Request for Bid
Wolf River Interceptor Rehab Addendum # 2 to
RFB No. 194677.71.0397
February 3, 2017

Section 3 – Updated Sections of Technical Specifications, Drawings, and Special Instructions

DESIGN STANDARD
FOR
REINFORCED CONCRETE
JUNCTION BOX

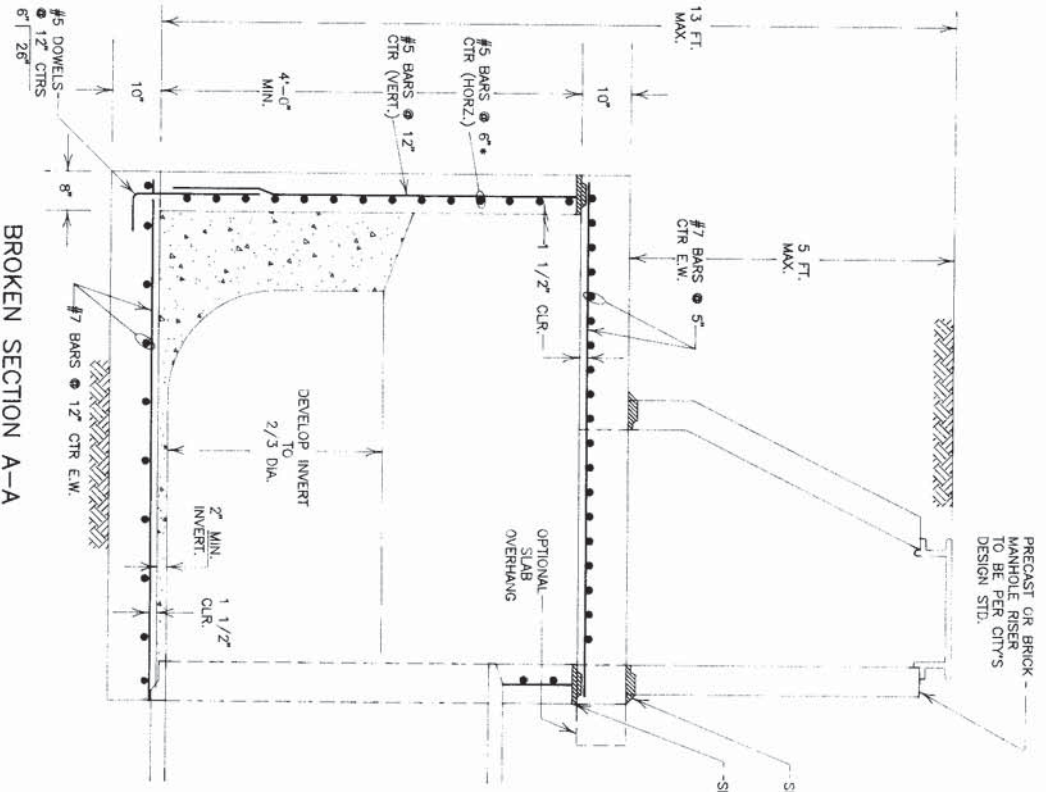
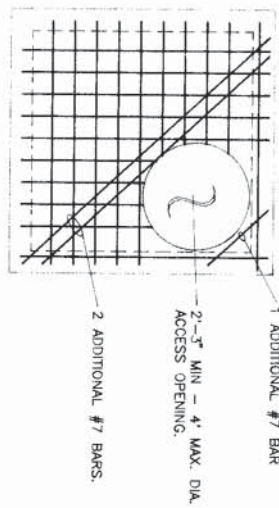
Q5: As listed in the Miscellaneous Construction Requirements, 2.C Item No. 09930.01 Special Structure for Bypass, there is not a detail in the technical specifications for this structure. This structure is to be set and to remain in place once complete. Can a detail be provided so that all contractors are looking at the design/construction of this structure in accordance with SARP10 expectations?

SARP10: This structure is to be designed as needed for bidders bypass needs. The design shall be approved by SARP10 prior to construction occurring. The finished structure shall be designed to City of Memphis standard drawing No.49 included in this addendum.
